ADDENDUM #3

GADSDEN CITY HALL

Gadsden, AL WBA #23-083.00

DATE: 13 December 2024

ROOF FRAMING PLAN

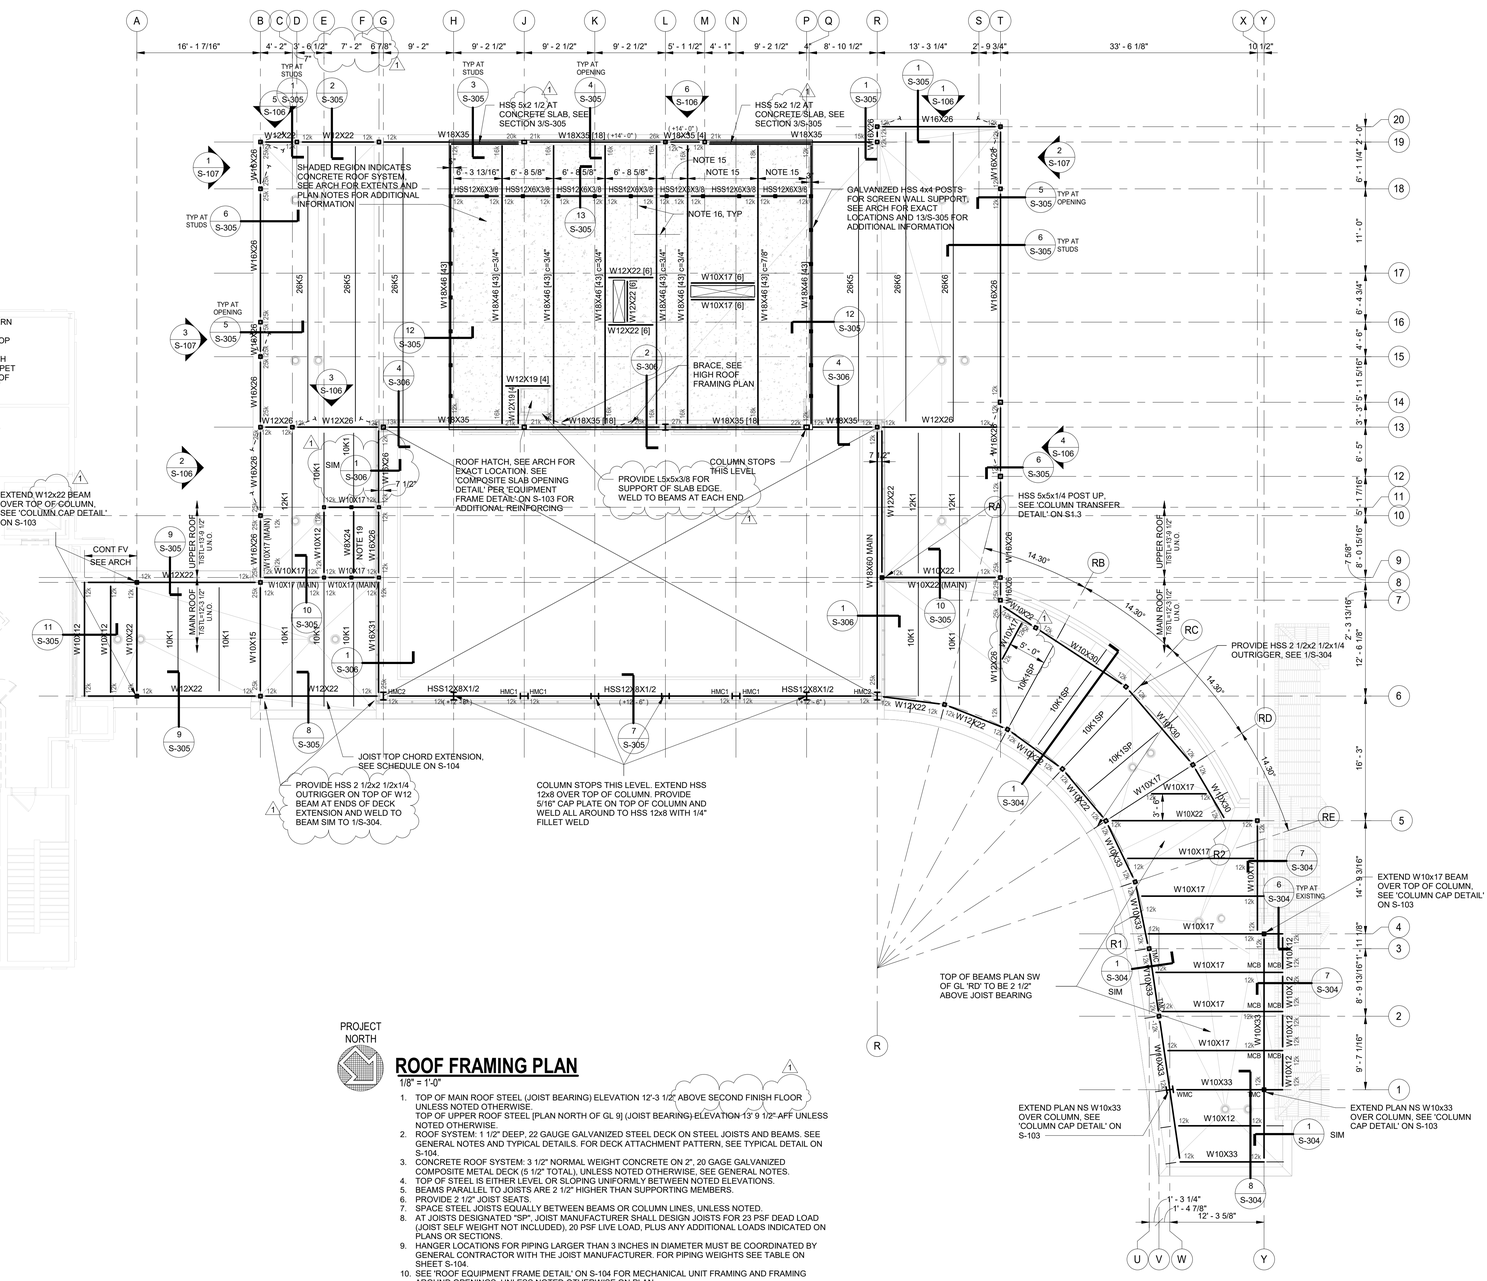
14. **Sheet S-203 – ROOF FRAMING PLAN:**
    a. Clarified grid dimensions.
    b. Added roof beam at walkway canopy roof.
    c. Added deck support along plan south edge of roof hatch.
    d. Added section 1/S-306 callout.
    e. Added plan note for deck support at deck cantilever between B6 and G6.
    f. Clarified miscellaneous notes on roof framing plan.
    g. Clarified miscellaneous notes on high roof framing plan.
    h. Clarified top of steel elevations for high roof framing plan.
    i. Clarified roof framing plan note 1.
    j. See attachments.

SECTION 3 S-303
3/4" = 1'-0"

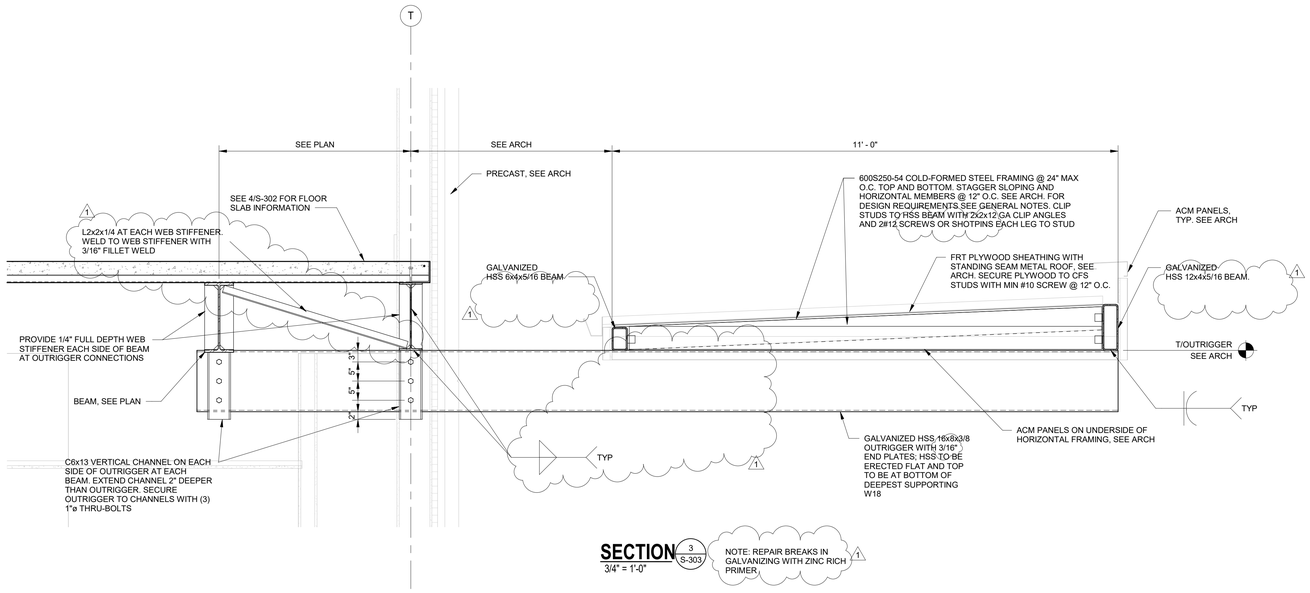
c. Section 3:
i. Added kicker between main beams.
ii. Updated CFS member support and connections.
iii. Updated miscellaneous weld information.
iv. Added section note.

SECTION 1 / S-304
3/4" = 1'-0"

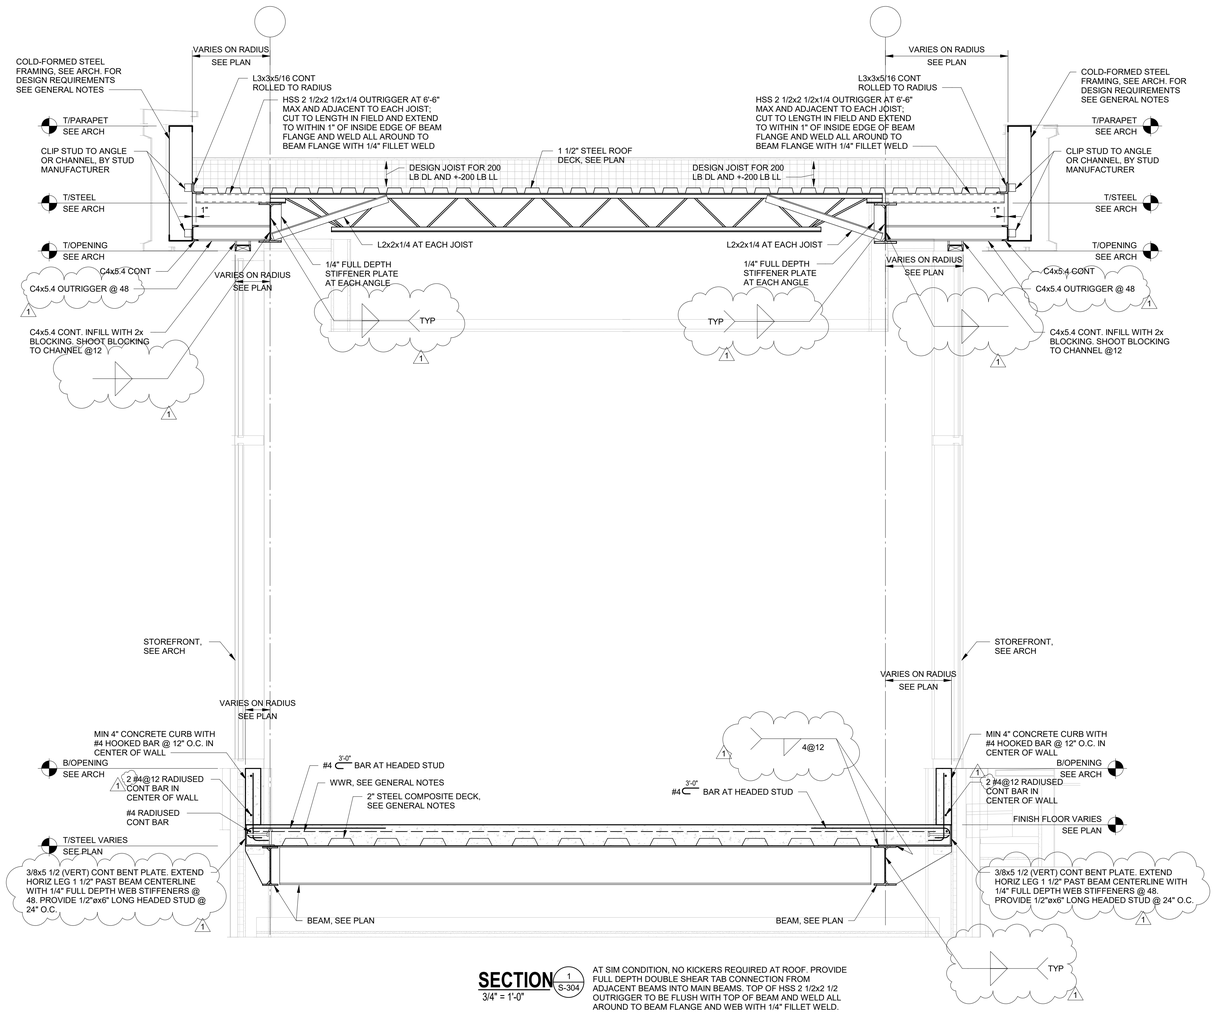
19. **Sheet S-304 – WALKWAY SECTIONS:**
a. Section 1:
i. Clarified outrigger notes.
ii. Updated miscellaneous weld information.
iii. Changed bent plate size, gusset plate size, and clarified miscellaneous weld information.
iv. Added number of continuous bars for concrete curb.

SECTION 8 / S-304
3/4" = 1'-0"

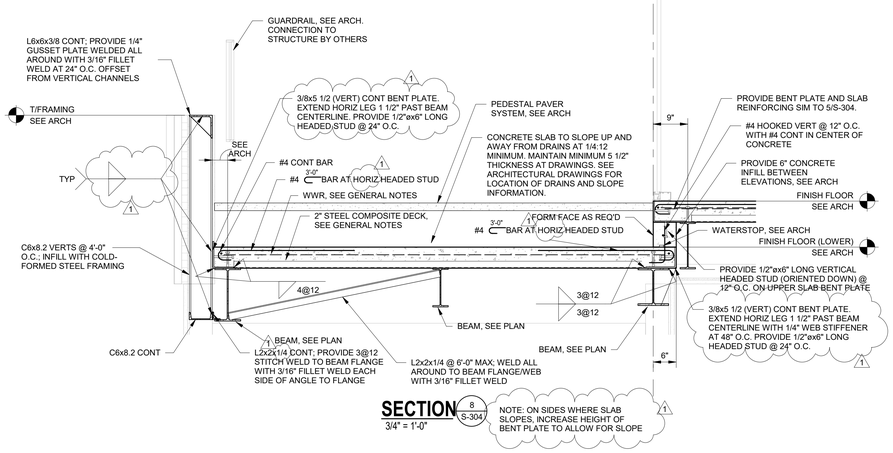
e. Section 8:
i. Clarified outrigger notes.
ii. Updated miscellaneous weld information.
iii. Clarified roof beam kicker location.
iv. Changed bent plate size, gusset size, and clarified miscellaneous weld information.
v. Clarified headed stud location.
vi. Added section note.

1 1ST FLOOR DEMOLITION PLAN - CITY HALL

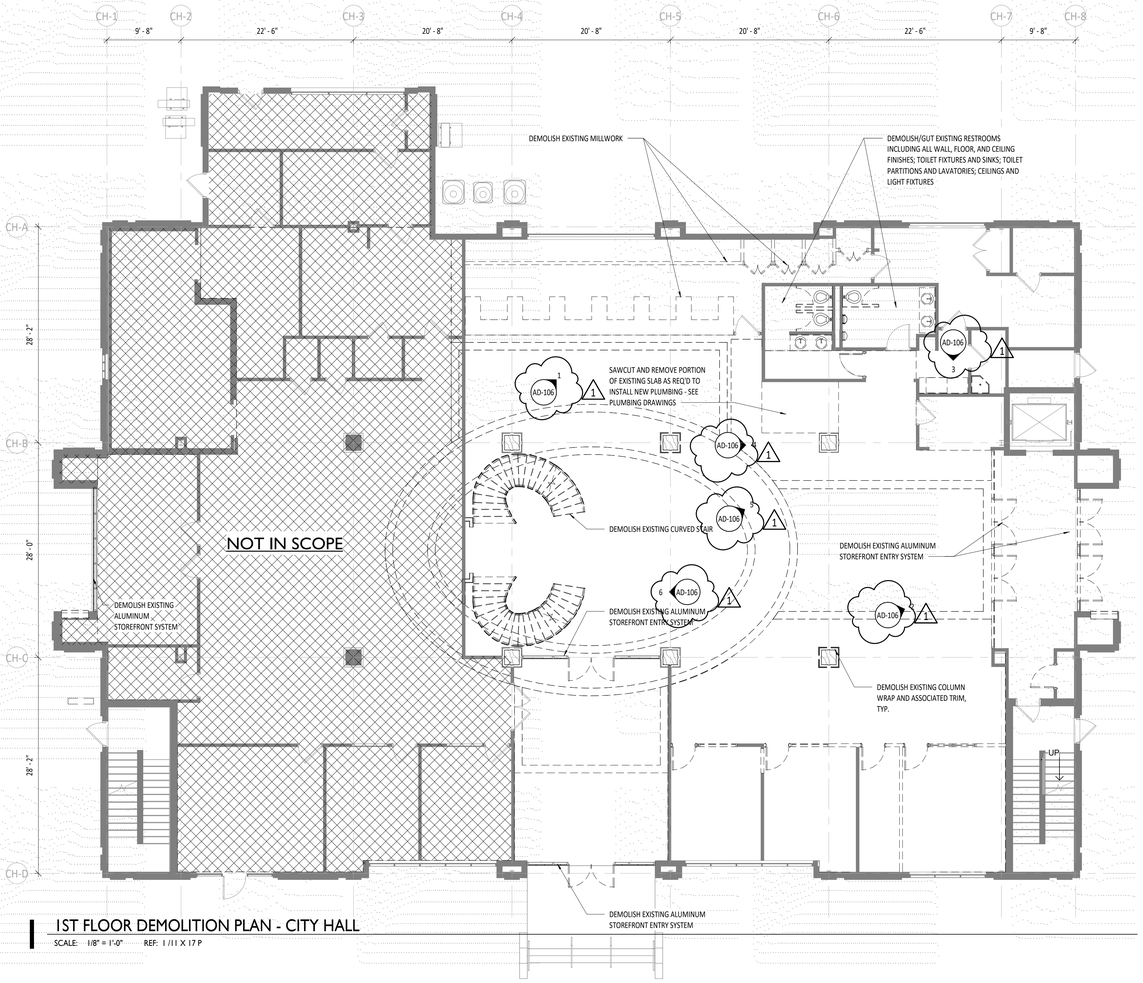
21. **Sheet AD-101 – 1st FLOOR DEMOLITION PLAN – CITY HALL:**
    a. Drawing 1/AD-101 – 1st FLOOR DEMOLITION PLAN – CITY HALL:
        i. Added callouts for demolition photos on sheet AD-106.
    b. Drawing 2/AD-101 – 1st FLOOR DEMOLITION RCP – CITY HALL:
        i. Add clarification notes.
        ii. Added callouts for demolition photos on sheet AD-106.
    c. Drawing 3/AD-101 – GUARDRAIL/SOFFIT DEMO:
        i. Revised not on detail for clarification.

CITY COUNCIL - 1ST FLOOR PLAN

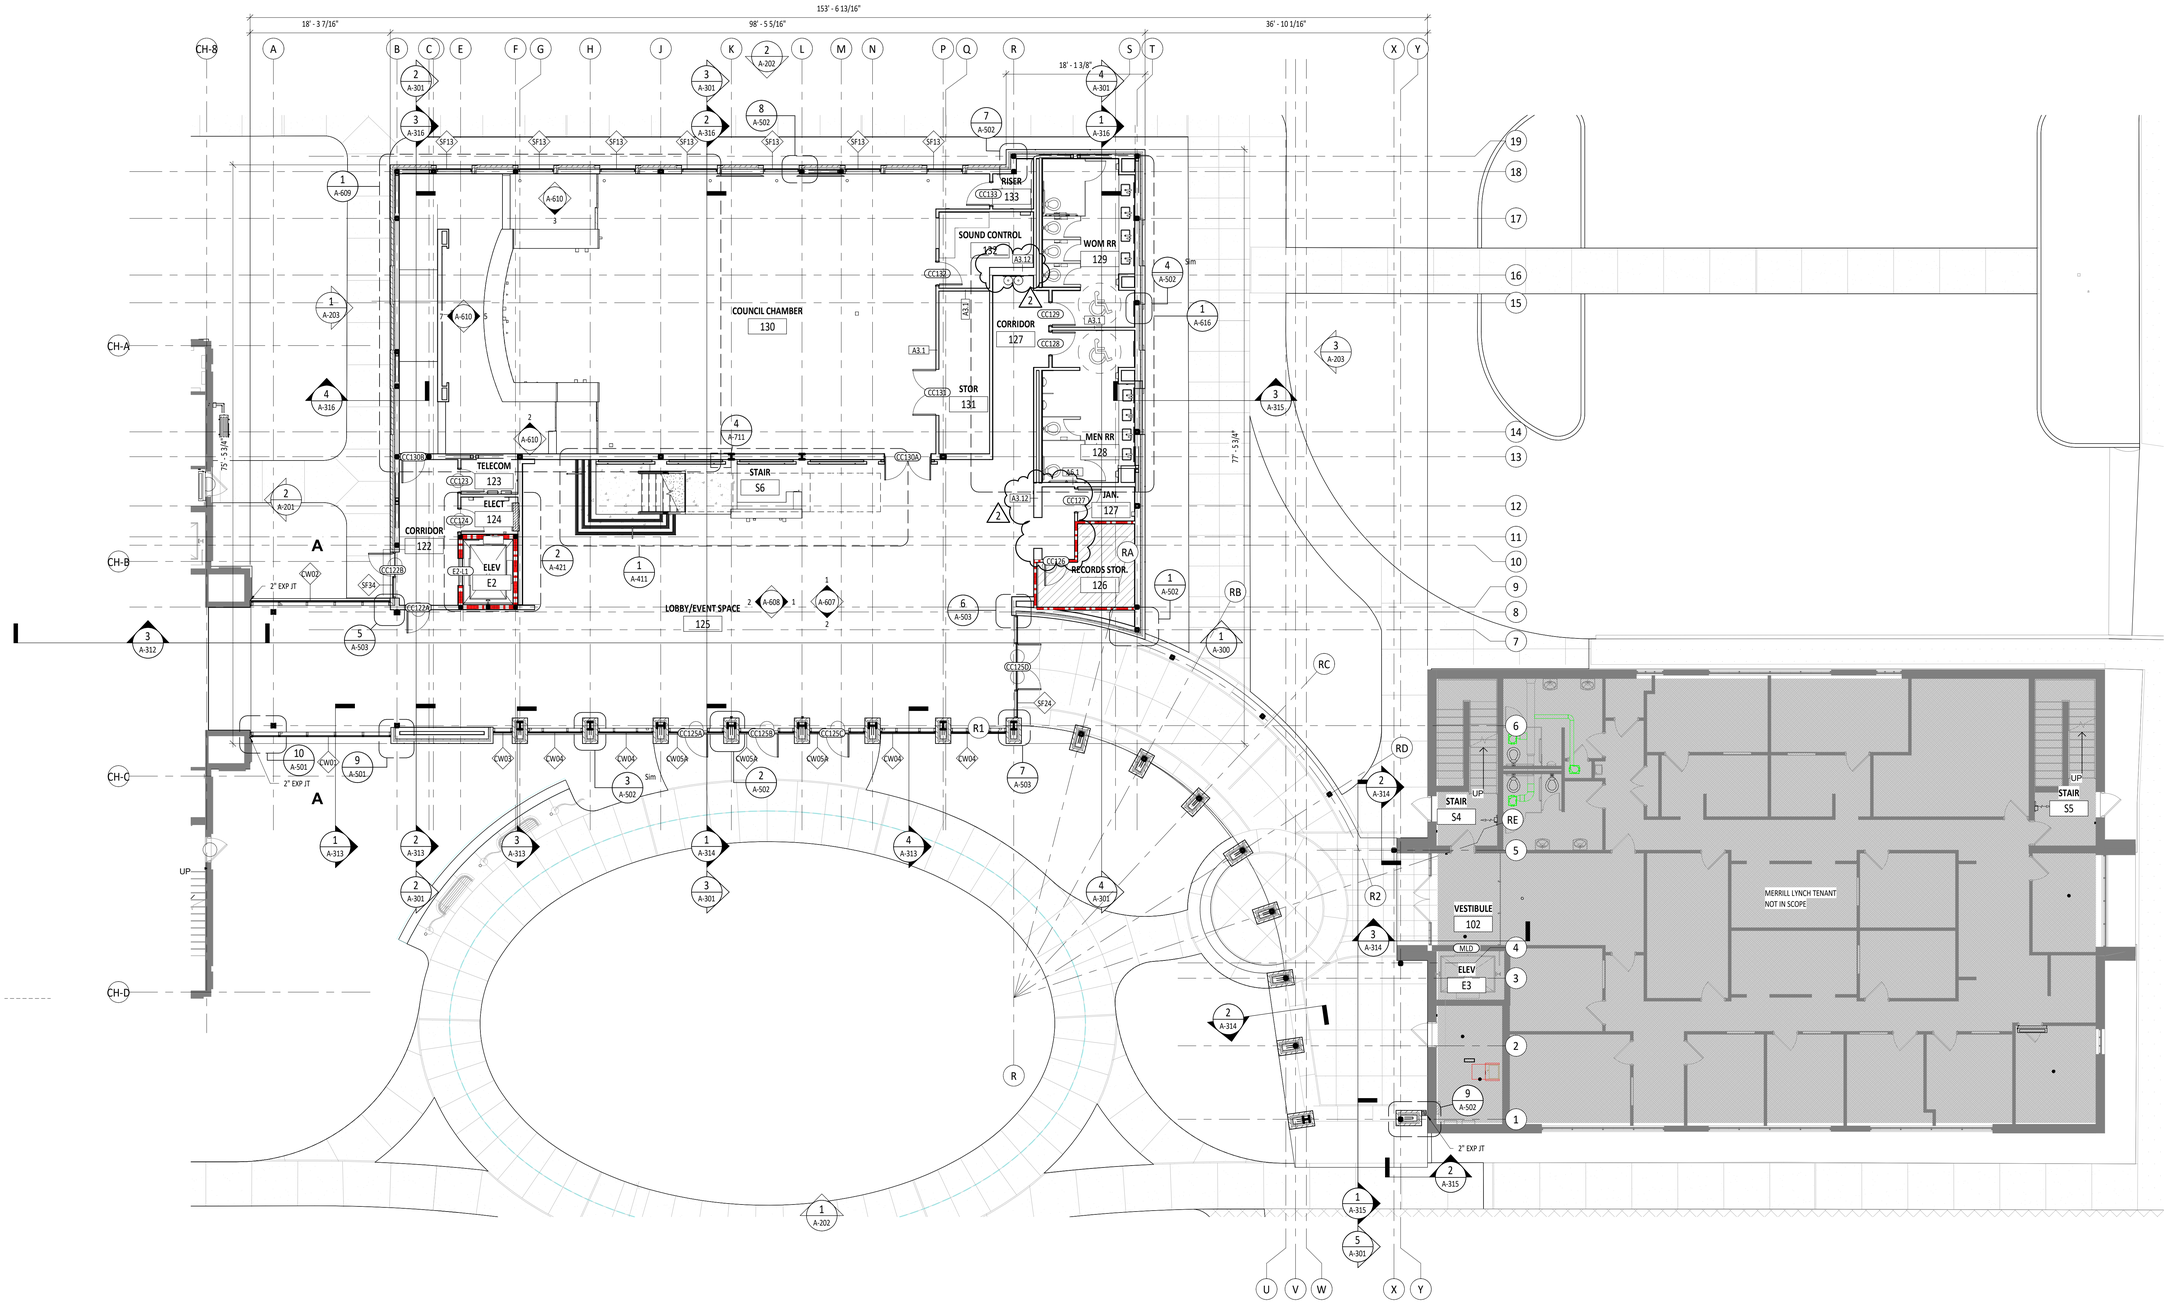
24. **Sheet A-109 – 1st FLOOR PLAN – CITY COUNCIL:**
    a. Changed wall type at SOUND CONTROL 132 to accommodate scheduled drinking fountain.
    b. Changed wall type adjacent to JAN. 127.
    c. See attachments.

SHEET NUMBER:
A-124

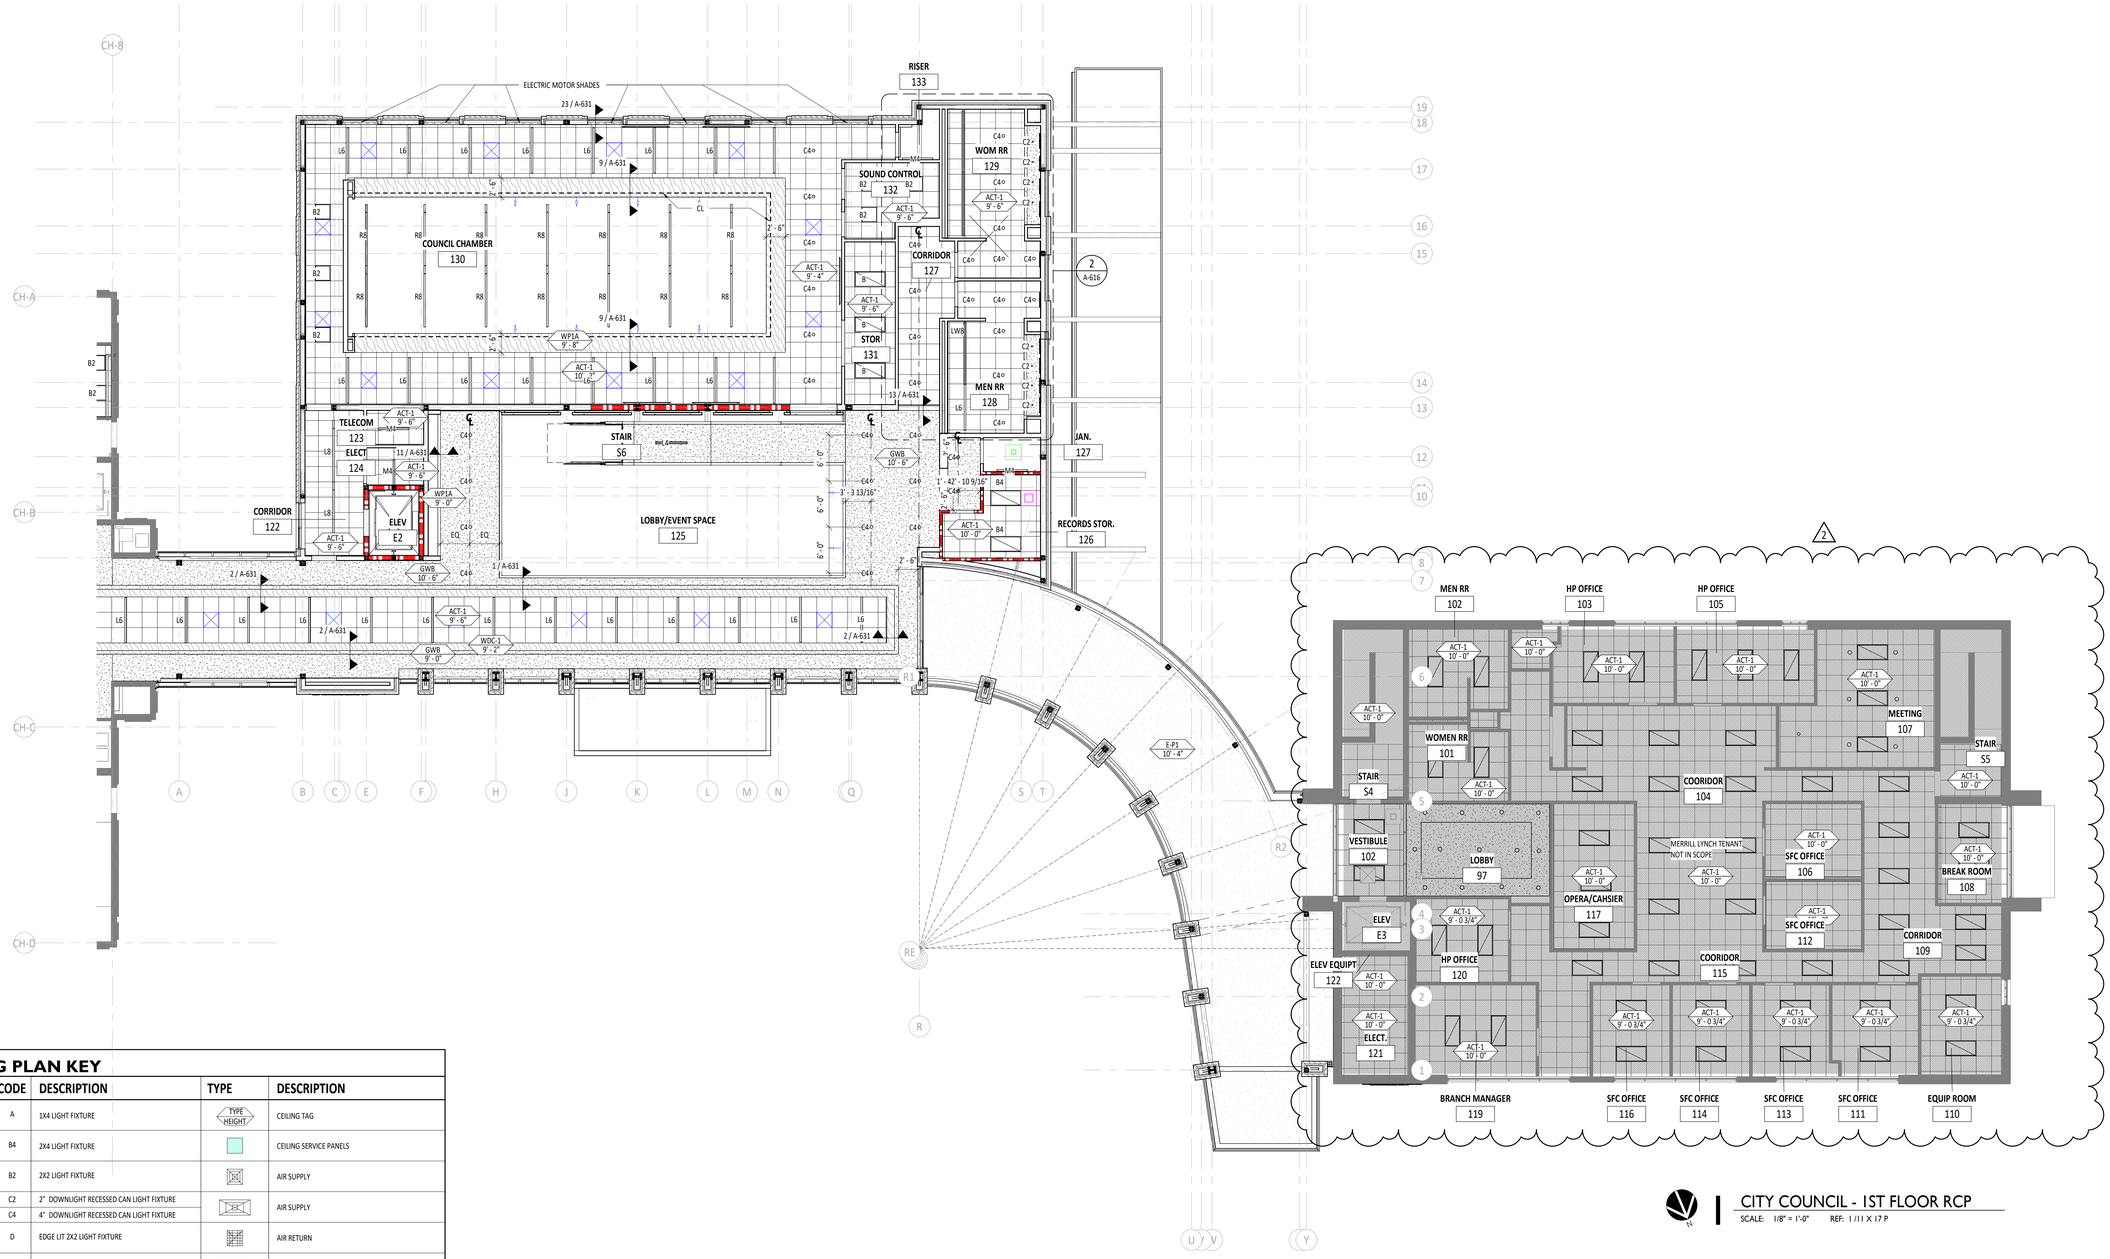
26. **Sheet A-124 – 1st FLOOR RCP – CITY COUNCIL:**
    a. Added shaded region and “MERRILL LYNCH TENANT NOT IN SCOPE” in the RCPs for clarification.
    b. See attachments.
